Comments to ECE/TRANS/WP.29/GRE/2011/30

The text reproduced below was prepared by the expert from OICA to address document ECE/TRANS/WP.29/GRE/2011/30 which concerns amendments to Regulation No. 48 for exterior courtesy lamps and manoeuvring lamps.

This OICA proposal covers the provisions for courtesy lamps in Regulation No. 48; it is drafted as 06 series of amendments to Regulation No. 48. The modifications regarding exterior courtesy lamps to the existing text of the Regulation are marked in **bold** for new or ~~strikethrough~~ for deleted characters.

Model A

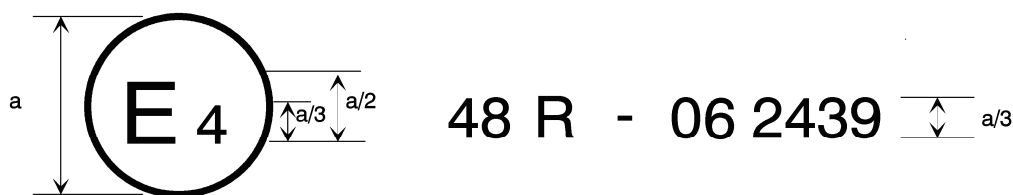
Annex 2, amend to read:

The above ...Regulation No. 48 as amended by the [06] series of amendments. The approval number indicates that the approval was granted in accordance with the requirements of Regulation No. 48 as amended by the [06] series of amendments.

Model B

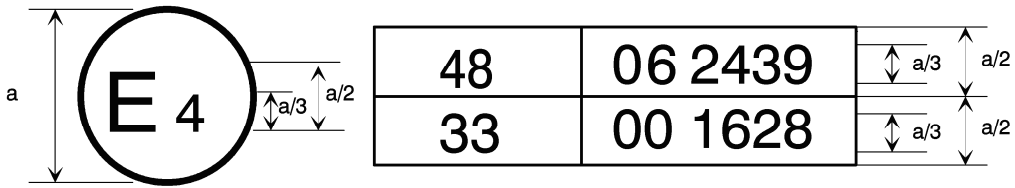
The above ...Regulation No. 48 as amended by the [06] series of amendments and Regulation No. 33.¹ The approval number indicates that, at the dates when the respective approvals were given, Regulation No. 48 was amended by the [06] series of amendments and Regulation No. 33 was still in its original form."
